TREE CONSERVATION REPORT  
ADDENDUM 2.1  
71 Russell Ave

Tree Conservation Report Addendum submitted as  
Partial Requirements for a Site Plan Control  
Application, May 29, 2026

## **Tree Conservation Report Addendum**

**Address:** 71 Russell Ave  
**Date of Report:** May 29, 2026  
**Date of Site Visit:** April 9, 2026  
**Prepared by:** Astrid Nielsen, RPF, ISA Certified Arborist ®  
101- 45 Spencer Ave, K1Y 2P5  
[Astrid.nielsen@dendronforestry.ca](mailto:Astrid.nielsen@dendronforestry.ca)  
**Client:** Colin Miller, [Colin@pinehillbuilders.ca](mailto:Colin@pinehillbuilders.ca)

Figure 1: Image clip from updated grading plan prepared by TL Mak dated May 27, 2026 showing the walkway curving around tree 1, city owned Norway maple. The distance from the edge of the tree trunk to the edge of the retaining wall is approximately 1.5 m.

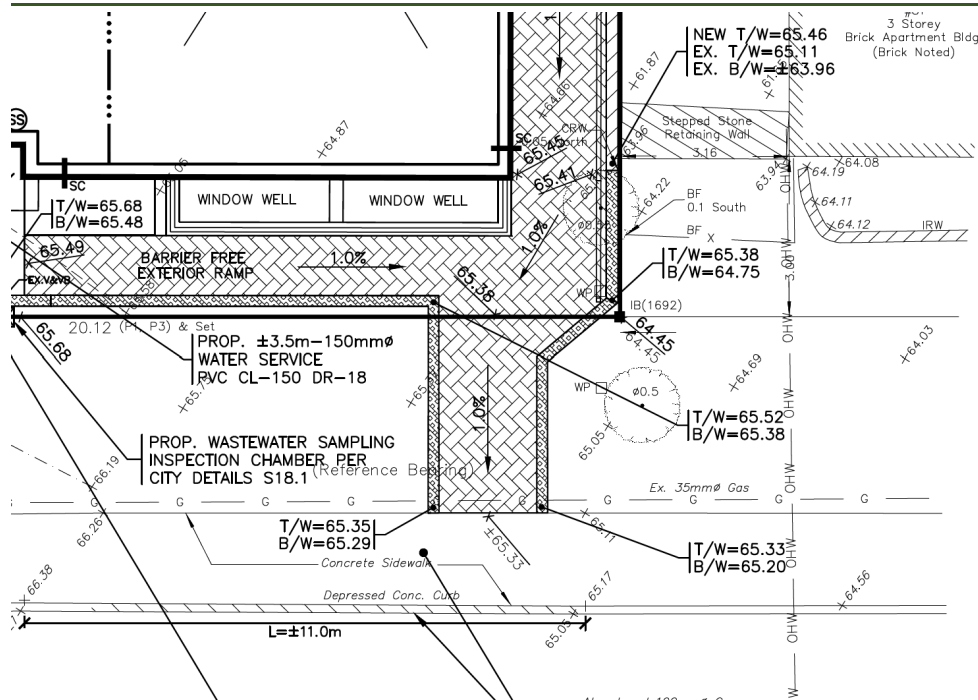
- 1. The retention plan for trees 1, 10 and 11 raises concern. Please provide more detail on the current growing condition of these trees, how much of the CRZs will be impacted by the proposed excavation and how far excavation is from the trunk of each tree. Address how the existing retaining wall beside trees 10 and 11 has influenced root growth and ensure the CRZs of these trees are accurately depicted. For tree 1, the proximity of the pavement and retaining wall is particularly concerning as it appears to be within the trees static root zone. There is concern over trees 1, 10 and 11 being made unstable by the extent of excavation/construction proposed in their proximity.

- 4. The tree protection fencing for trees 10 and 11 overlaps with the proposed stairs and with a future talkway and curb for tree 1. This is unrealistic. Please address in the TCR and provide more details on the plan and how it can be executed as planned.

**Tree 1:** This updated report reflects changes that were made to the grading plan for the walkway to curve around the tree. The new walkway and retaining wall will be approximately 1.5 m from the edge of the tree trunk which should avoid impacting the structural integrity of the tree. The tree roots are to be pruned in advance of any excavation for the walkway and retaining wall and be completed by a certified arborist and/or city forestry staff. The same applies to the removal of any branches for the clearance of equipment on site.
